City of Mississauga Department Comments

File(s): A487.23 Ward: 5

The applicant requests the Committee to approve a minor variance to allow a driveway proposing a driveway width of 6.80m (approx. 22.31ft) whereas By-law 0225-2007, as amended, permits a maximum driveway width of 5.20m (approx. 17.06ft) in this instance.

Property Address: 7467 Sigsbee Drive

Appendix 1 – Transportation and Works Comments

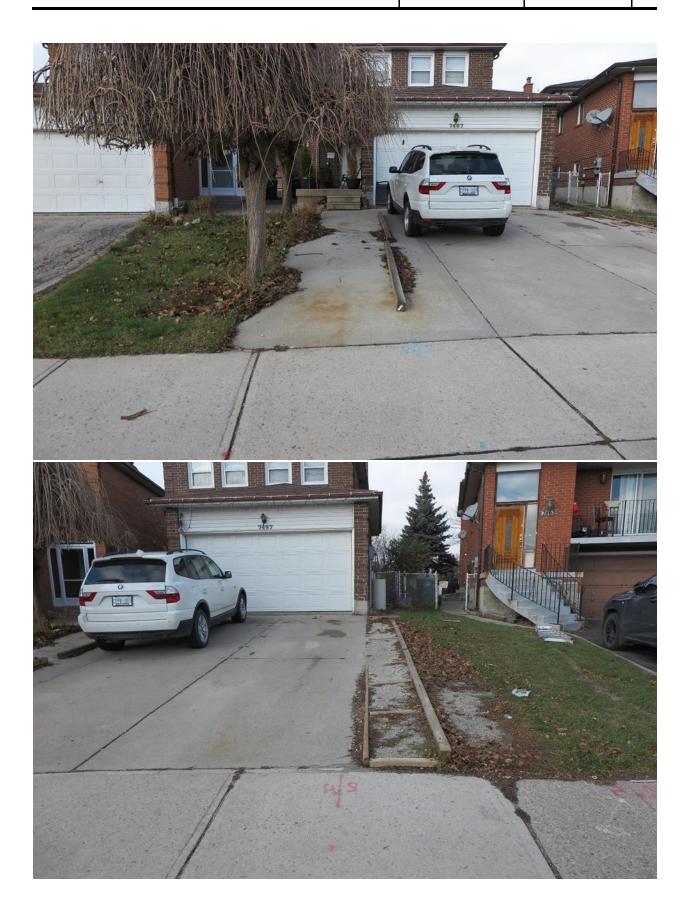
This department notes that with regard to the widened driveway within the municipal boulevard (the area between the municipal curb and property line) we would request that this area be reinstated with topsoil and sod should the application be modified to reflect a smaller driveway width within the subject property or if the application is not supported by the Committee.
